2 Type of change

Reinforced socket ground with ribs.

1681 Appliance Inlet					0118.2315	
creation date	created by	release date	released by	notification no.	revision	page
2015-11-06	huberth	2015-11-09	huberth		-	1 of 2

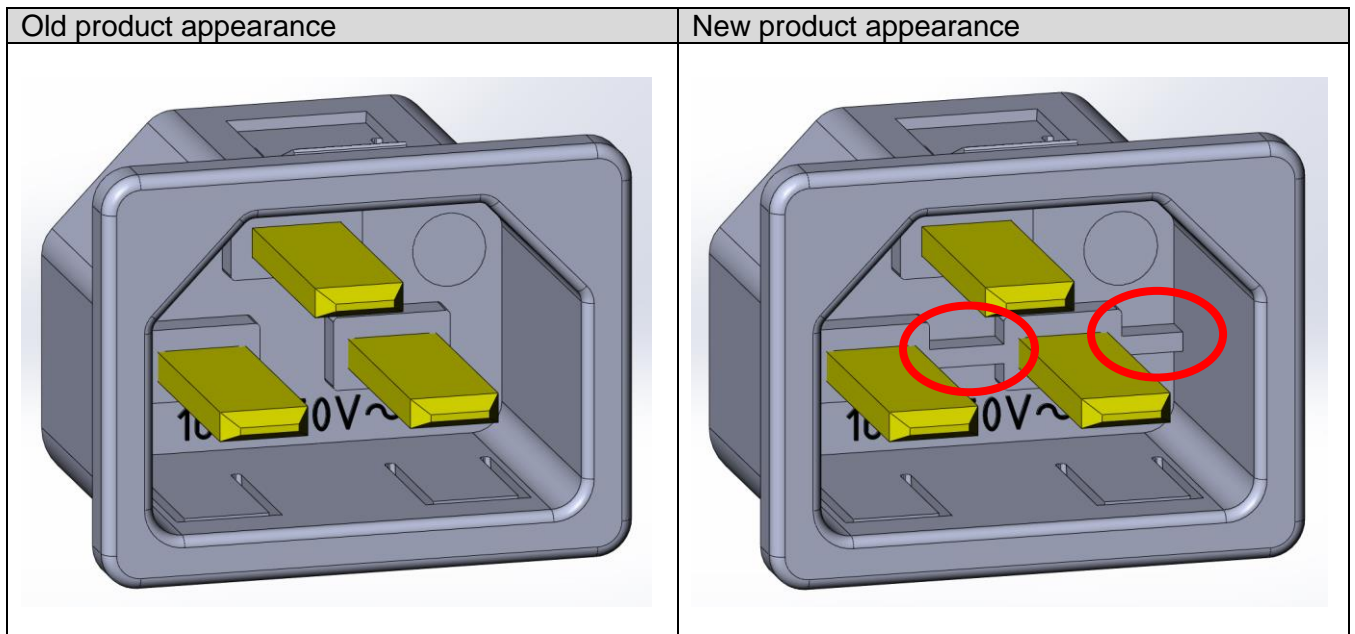
Reinforced socket ground in the area of breakthroughs for L and N terminals. (snap-in types only)

To guarantee the dimensions (direction) of the pins according to IEC 60320.

Form: Additional ribs between the breakthroughs on the socket ground (inside)
Fit: No There are no dimensional changes
Function: No This is a non-functional change
Production Site: No There is no change of the production site
Product Label: No There is no change on the label
Customer action: No There is no customer action required
